**SUBDIVISION VARIANCE REVIEW SHEET****CASE NO.:** C8-2015-0227.0A**P.C. DATE:** 04-26-16**SUBDIVISION NAME:** 1023 Springdale Subdivision**AREA:** 9.99 acres**LOT(S):** 1**OWNER/APPLICANT:** 1023 Holdings, LLC  
(Daryl Kunik)**AGENT:** 1023 Holdings, LLC  
(Daryl Kunik)**ADDRESS OF SUBDIVISION:** 1023 SPRINGDALE RD**GRIDS:** ML22**COUNTY:** Travis**WATERSHED:** Boggy Creek**JURISDICTION:** Full Purpose**EXISTING ZONING:** CS-CO-NP**DISTRICT:** 3**NEIGHBORHOOD PLAN:** MLK**PROPOSED LAND USE:** Commercial**ADMINISTRATIVE WAIVERS:** None

SUBJECT: 1023 Springdale Subdivision (C8-2015-0227.0A)  
Variance of Title 25, Section 25-4-151 (Street Connection)

RE: 1023 Springdale Subdivision  
C8-2015-0227.0A

## 1023 SUBDIVISION

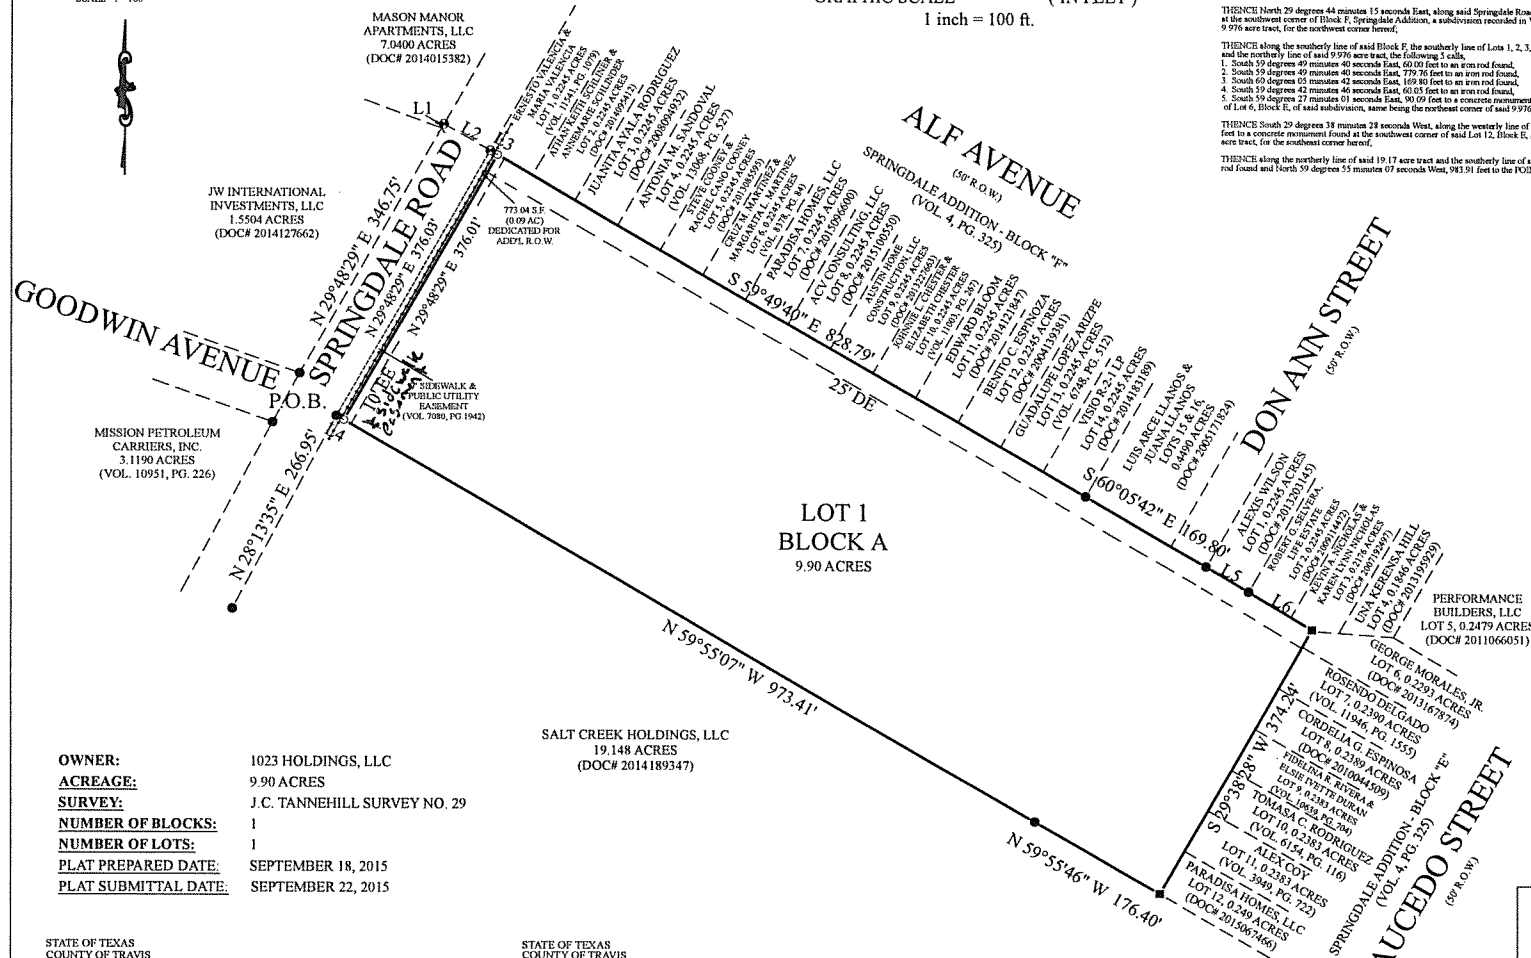
**VARIANCES:** The applicant requests a variance from LDC section 25-4-151 which requires that streets in a new subdivision shall be aligned with and connect to existing streets on adjoining property. The applicant proposes to not extend Don Ann Street into the proposed subdivision.

Greetings and I hope you're both doing well. Please see the attached final plat which shows Don Ann Street abutting the proposed subdivision on the north side. The applicant has requested a variance not to extend Don Ann Street thru their commercial property since it is a local residential street that was never built and was dedicated as ROW with a residential subdivision which dates back to 1947.

However, during the review, it was determined that a land use commission variance would be needed in order not to extend an old existing ROW (vacant) that abuts the property.

**RECOMMENDED.** See attached memorandum from transportation review.

**STAFF RECOMMENDATION:** The staff recommends approval of the variance request.

We will add a note, "A VARIANCE TO LDC 25-4-151, STREET ALIGNMENT AND CONNECTIVITY WAS GRANTED BY THE PLANNING COMMISSION ON \_\_\_\_\_".
